**Subject:** Material for today's Light-duty GHG NPRM discussion.

# Summary points from EPA review of CAFE model (NPRM version) – Effect of EPA code revisions

# EPA Initial Review of CAFE Model & Inputs, February 9, 2018

**Figure 10 Effect of truncating CO<sub>2</sub> credit value in CAFE model’s ‘efficiency’ calculation for tech package selection**  
Assuming \$3/gal fuel price, \$35/MgCO<sub>2</sub> credit value, and 30k miles driving in first 2.5 years (for consumer payback)

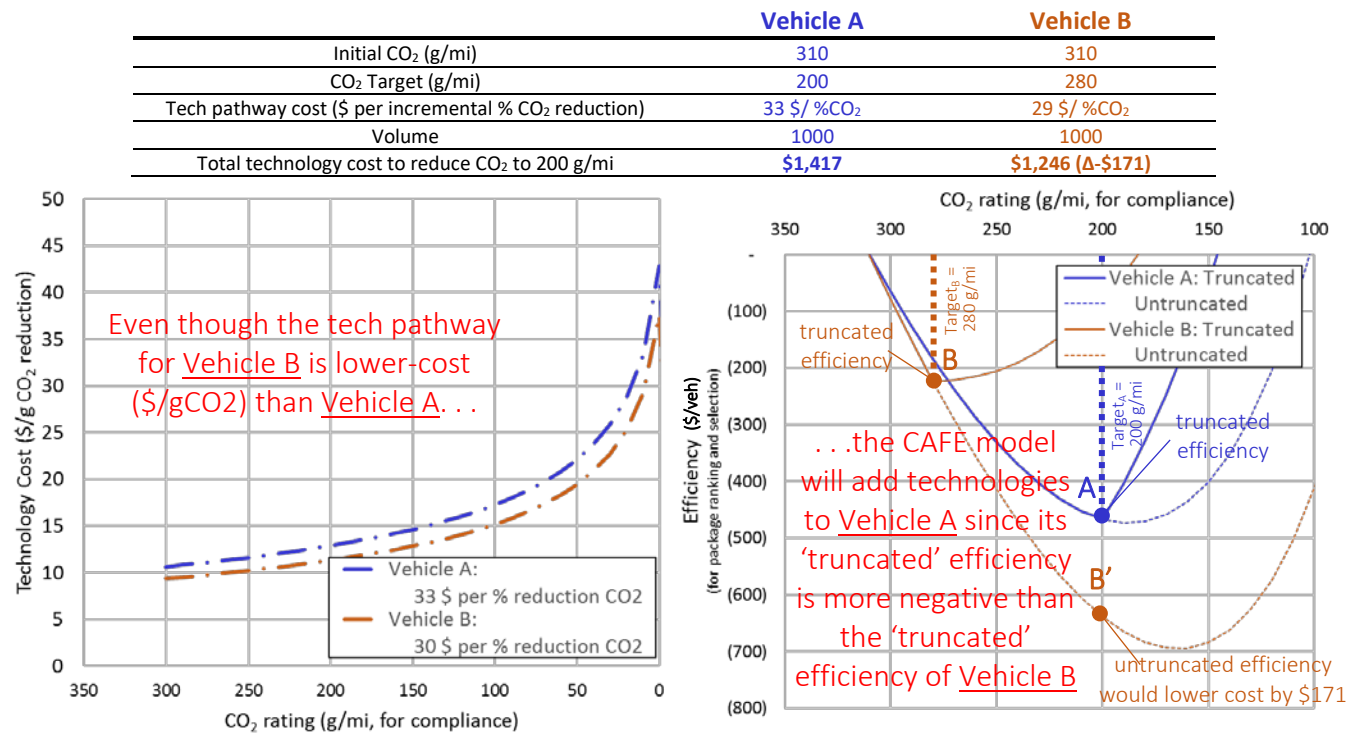
as shown in Figure 10, since the credit value for reducing Vehicle B below its 280 g/mi target is truncated and not included in the efficiency calculation. The CAFE model will choose to apply technology to Vehicle A to reduce CO<sub>2</sub> to 200 g/mi, even though that technology pathway is less cost effective than one where technology is applied to Vehicle B (point B' in Figure 10) – with a technology cost of \$1,417 for Vehicle A compared to \$1,246 for Vehicle B for the same CO<sub>2</sub> reduction.

**Figure 1 Incremental Effectiveness of TURBO1 to TURBO2 (MedSUV class)**

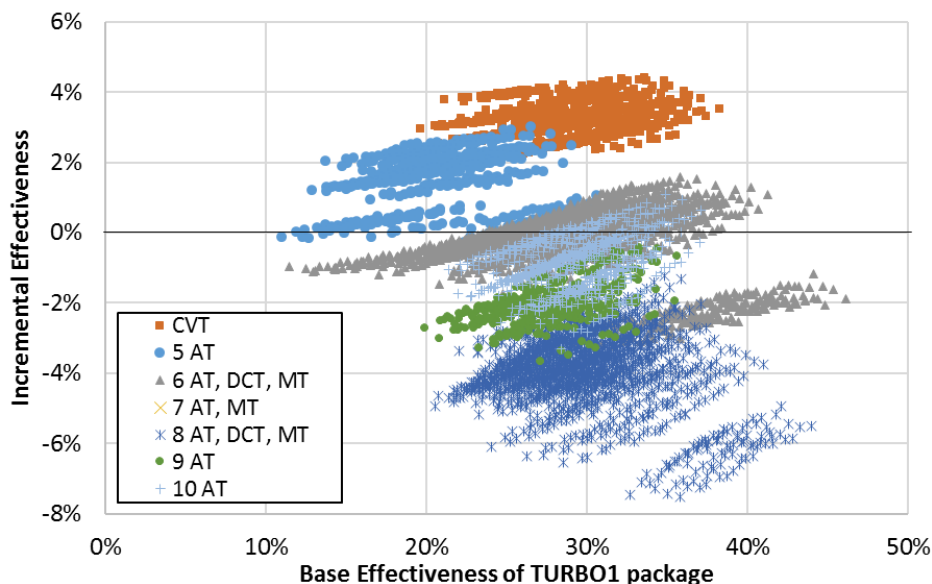
The technology inputs include two levels of turbocharged engines, TURBO1 and TURBO2. The incremental cost of TURBO2 hardware over TURBO1 hardware is about \$350 to \$700 in 2030; although it is unclear what specific technologies are represented by this cost, one would expect a generally higher effectiveness. However, depending on the package and car class, the actual incremental effectiveness values from the NHTSA technology inputs for the TURBO2 technology is often negative. The “Medium SUV” class, shown in Figure 1 has the most pronounced effect, **with the addition of the TURBO2 technology, on average, having a negative effectiveness.**

**Figure 2 Incremental Effectiveness of TURBO2 to CEGR1 (MedCarPerf class)**

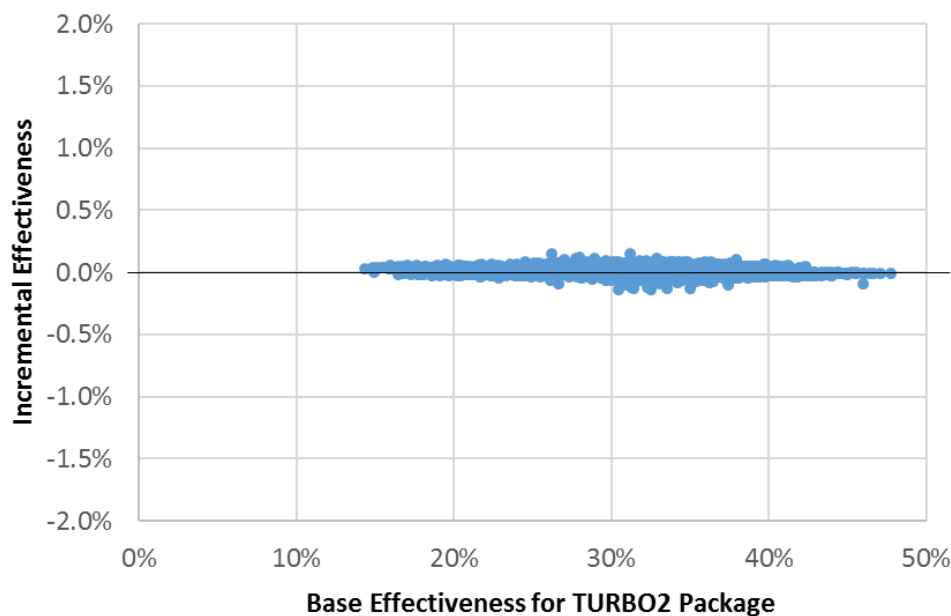
**Observation 3:** *The addition of cooled exhaust gas recirculation (CEGR1) onto turbocharged engines (TURBO2) provides no relative benefit, despite the additional cost of the technology. Given this input assumption, the CAFE model outputs, as expected, do not show application of CEGR1.*

A cooled EGR package when added to the advanced turbocharged engine (TURBO2) has a cost of \$334 in 2030. Cooled EGR is a technology that has been used in the market, and has a significant effect on CO<sub>2</sub> reduction. However, as illustrated in Figure 2, the incremental effectiveness is at or near zero for EPA findings on initial review of NHTSA Jan-22, 2018 CAFE model runs (final version for 2/12/2018 NHTSA briefing)

**Figure 3 Incremental Effectiveness of the best six-speed (AT6L2) v. the best eight-speed (AT8L3) (Small SUV)**

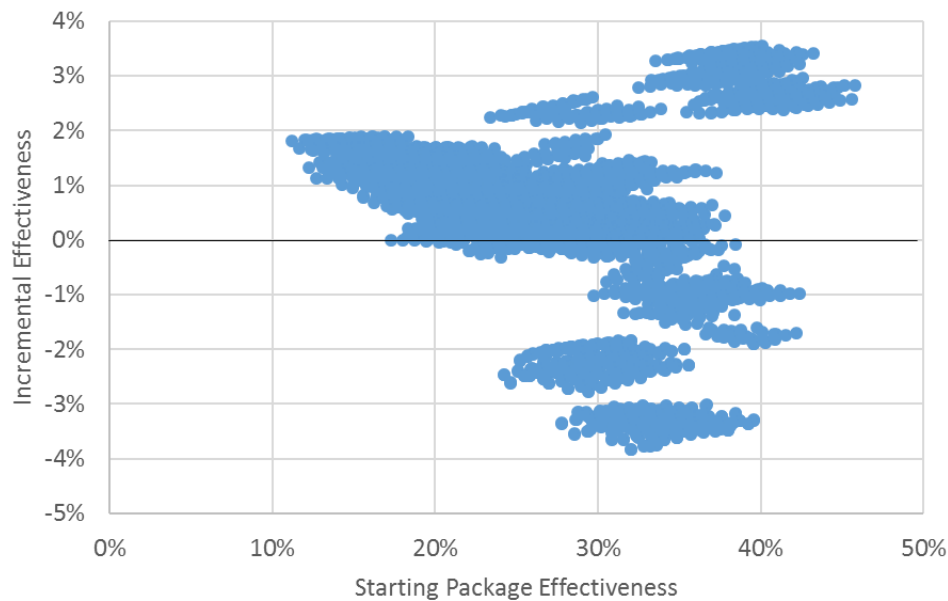
The modeled automatic transmissions include one “improved” level of a six-speed automatic (AT6L2) and two improved levels of eight-speed automatics (AT8L2 and AT8L3). The cost of the AT6L2 package (additional to an AT6) is \$362 in 2030. The cost of the AT8L3 package (additional to an AT8) in 2030 is nearly the same (\$358). Incremental to the AT6, the best eight-speed package is \$485 (i.e., \$123 more than the AT6L2). However, on average, the technology inputs provided show that the AT8L3 is only 1% more effective than the AT6L2, and in some cases is worse (as shown by the Small SUV plot).

**Figure 4 Incremental Effectiveness of six-speed (6AT) to eight-speed (8AT) for Pickup and Medium Car**

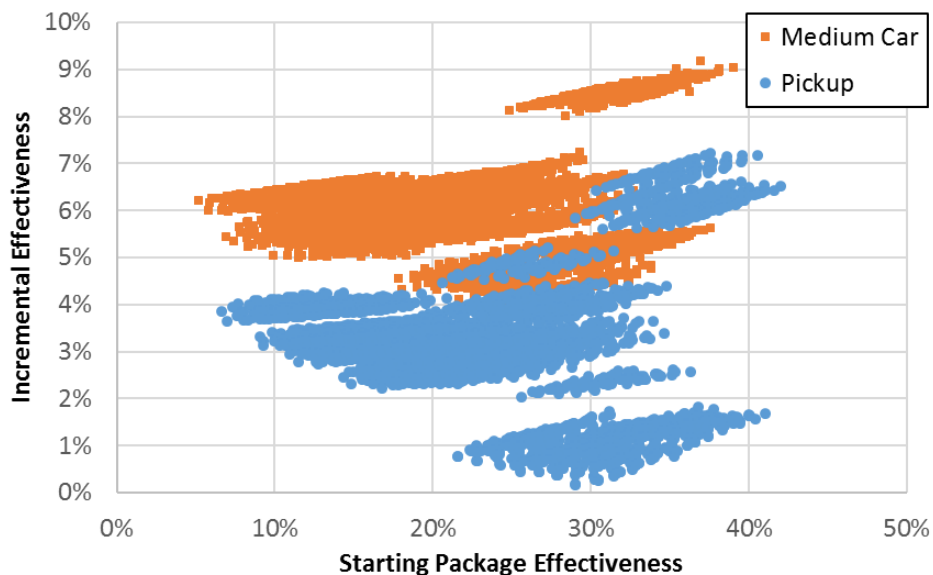
The technology inputs provided seem to show that the incremental effectiveness associated with moving from a six-speed transmission (AT6) to an eight-speed transmissions (AT8) is noticeably different depending on class. The figure shows effectiveness for a medium car and a pickup; on average, the eight-speed effectiveness for the car is about twice that for the truck. This trend seems to hold for the small and medium car classes, which have AT8 effectiveness about twice that of the medium SUVs and trucks (with the small SUVs in between). This may be due to assumptions about front-and rear-wheel drive systems; however, comments from stakeholders have indicated that RWD systems should have greater potential for transmission effectiveness improvements, as packaging more gears in the space provided is less of a concern.

**Figure 5 Incremental Effectiveness of 48V Mild Hybrid with belt-integrated starter-generator (BISG) to crank-integrated starter-generator (CISG) (Small Car class)**

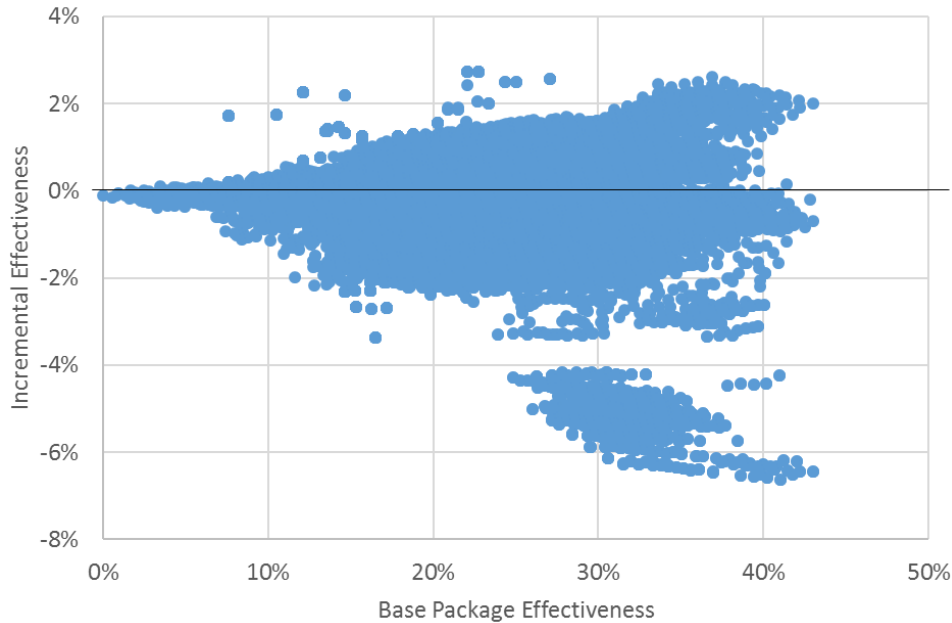
However, on average, the CISG is slightly less effective than the BISG, although with a wide spread of effectiveness. The small car example shown in Figure 5 is typical, with the incremental effectiveness of most packages between about +1% and -1%.

**Figure 6 Incremental Effectiveness of CONV to SS12V for Small Car class (left) and Medium SUV Perf class (right)**

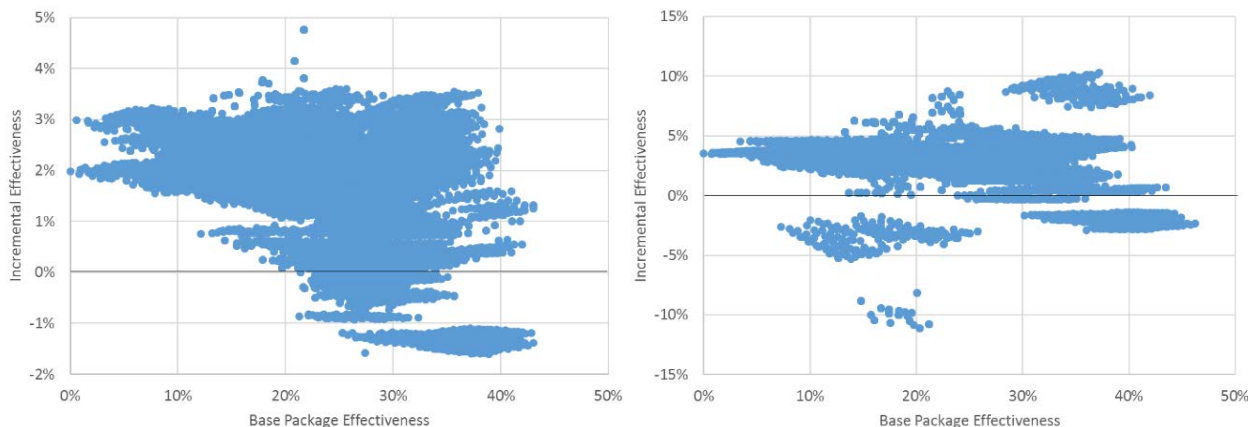
The cost of stop-start technology is either \$466 or \$521 in 2030, depending on vehicle class, plus about \$582 in battery costs. However, there are some packages where the provided technology inputs indicate a negative effectiveness, as shown in Figure 6 for the small car class below. Moreover, there are a few packages in some classes that are clear outliers (see the medium SUV performance class), **either high or low.**

Figure 6 Incremental Effectiveness of TURBO1 to TURBO2 (MedSUV class)

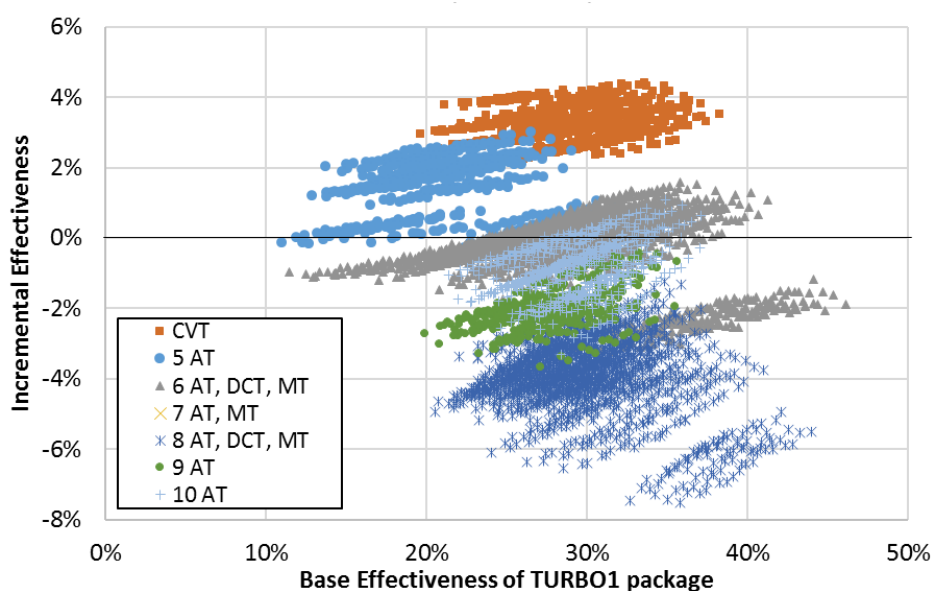
The technology inputs include two levels of turbocharged engines, TURBO1 and TURBO2. The incremental cost of TURBO2 hardware over TURBO1 hardware is about \$350 to \$700 in 2030; although it is unclear what specific technologies are represented by this cost, one would expect a generally higher effectiveness. However, depending on the package and car class, the actual incremental effectiveness values from the NHTSA technology inputs for the TURBO2 technology is often negative. The “Medium SUV” class, shown in Figure 8 has the most pronounced effect, with the addition of the TURBO2 technology, on average, having a negative effectiveness.

**Figure 7 Incremental Effectiveness of TURBO2 to CEGR1 (MedCarPerf class)**

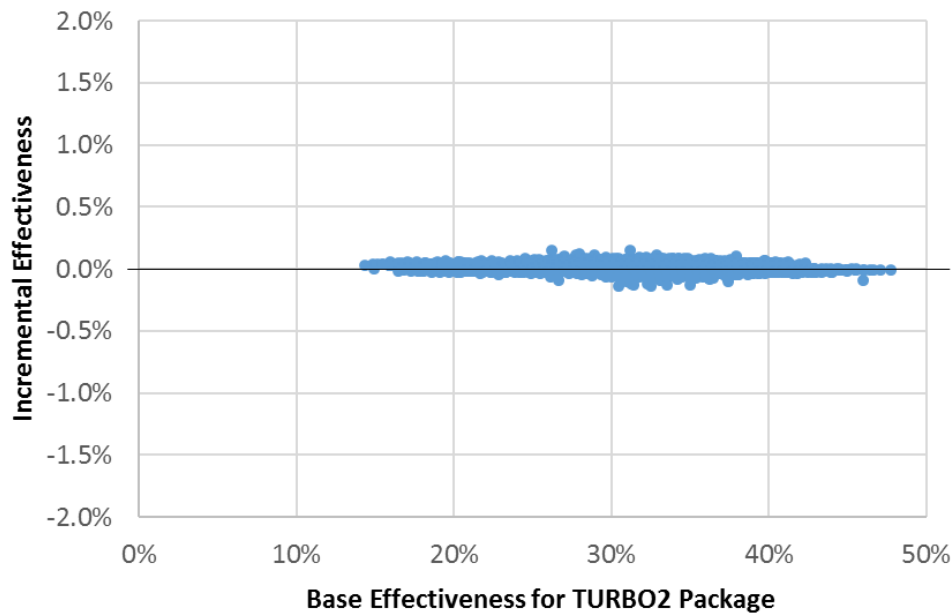
A cooled EGR package when added to the advanced turbocharged engine (TURBO2) has a cost of \$334 in 2030. Cooled EGR is a technology that has been used in the market, and has a significant effect on CO<sub>2</sub> reduction. However, as illustrated in Figure 9, the incremental effectiveness is at or near zero for nearly all packages (and averaging zero for all packages). The “Medium Car Performance” class shown in the figure is representative of the near-zero effect of the technology for all classes.

**Figure 9: EPA Observations of Transmission Effectiveness**

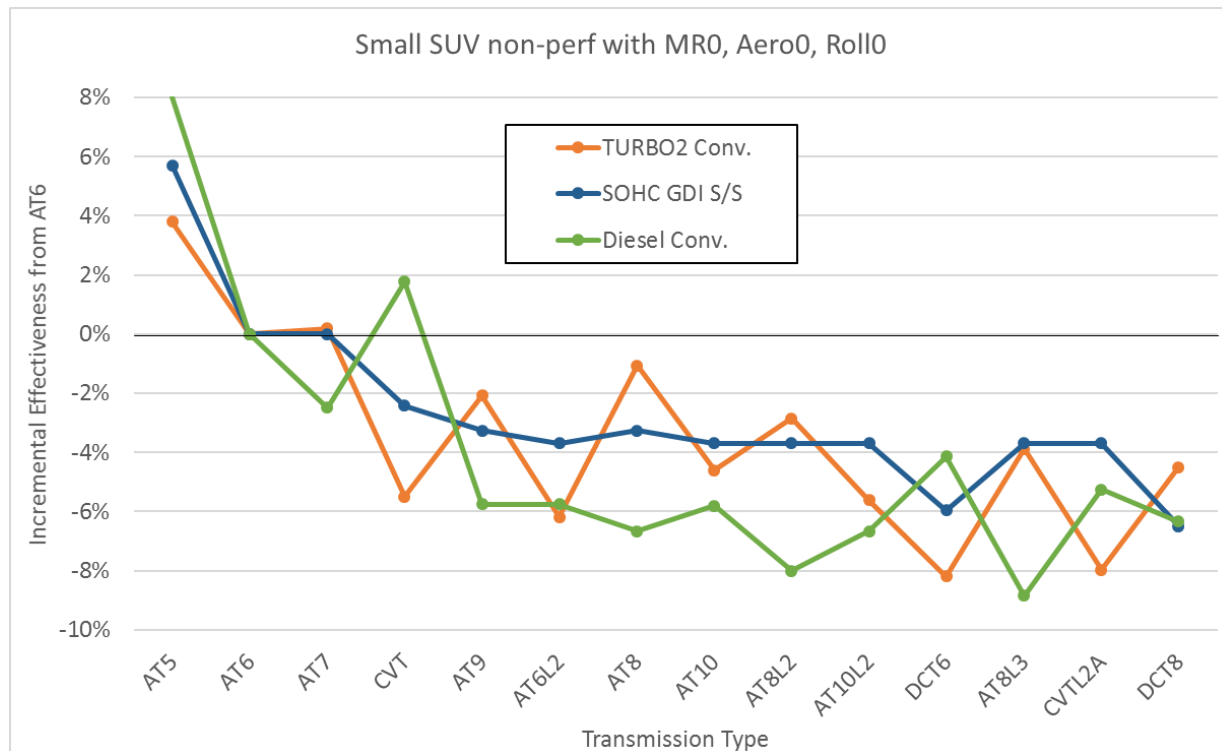
As part of the review process with NHTSA, NHTSA requested additional information and specific examples of vehicle technologies that did not follow the logical progression of transmission technology and commensurate effectiveness. In response EPA provided Figure 9: EPA observations of transmission effectiveness below. This figure shows that as advanced transmission technologies are applied to several powertrain types, there are instances where the more advanced transmission demonstrates lower effectiveness than the less advanced transmission. In addition, to this chart EPA also provided the exact technology package references from the CAFE model inputs. As of this summary, NHTSA has not yet responded to this observation.

**Figure 12: EPA’s Observations of Negative Effectiveness for Start/Stop Packages**

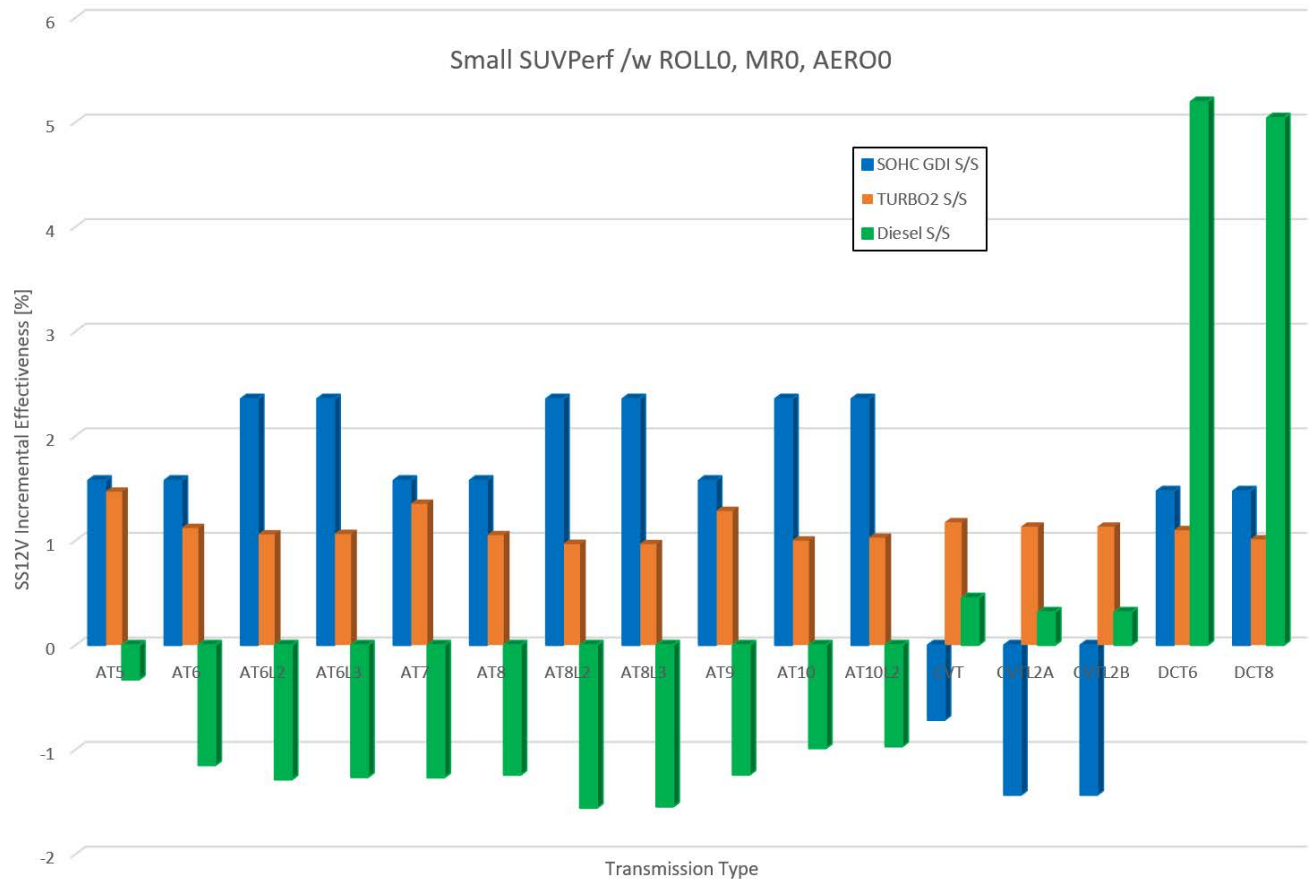
In addition to examples of unexpected transmission effectiveness estimates, NHTSA also requested examples of observed negative 12V start-stop effectiveness. In Figure 12: EPA's Observations of Negative Effectiveness for Start/Stop Packages, below, EPA has identified 12V start/stop packages that demonstrate negative effectiveness. These results are not rational. There are not situations under which turning off the engine instead of allowing the engine to idle would result in increased fuel consumption. In addition, for those packages with the same engine and positive effectiveness, it is also unexpected to observe such large variation in start/stop effectiveness. A SOHC GDI S/S should consume the same amount of fuel at idle independent of being mated to an AT8 transmission or an AT8L2 transmission.

**Figure 13 Incremental Effectiveness of CONV to SS12V for Small Car class (left) and Medium SUV Perf class (right)**

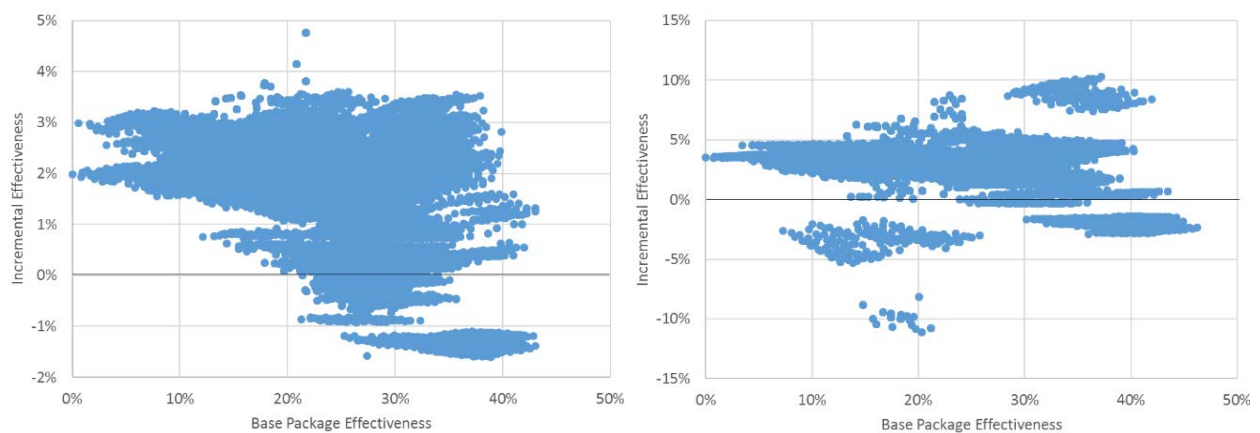
The cost of stop-start technology is either \$466 or \$521 in 2030, depending on vehicle class, plus about \$582 in battery costs. However, there are some packages where the provided technology inputs indicate a negative effectiveness, as shown in Figure 13 for the small car class below. Moreover, there are a few packages in some classes that are clear outliers (see the medium SUV performance class), either high or low.

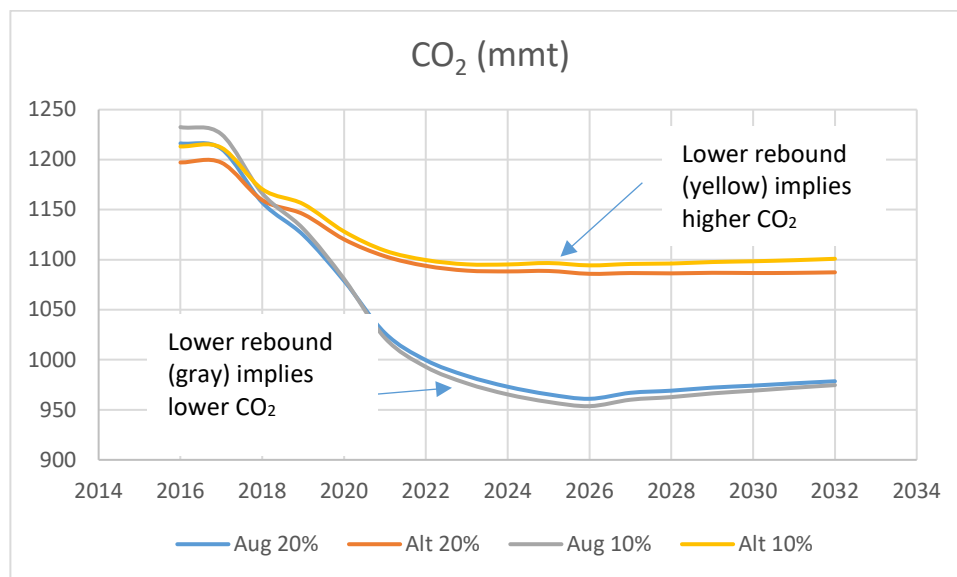
**Question/Information Request 13.** Can NHTSA provide an explanation for why such a dramatic decline in annual VMT occurs after age 6, and considering that large decline why does NHTSA believe that the IHS/Polk data is more defensible than multiple other sources which are based on population-weighted samples of odometer readings of individual vehicles.
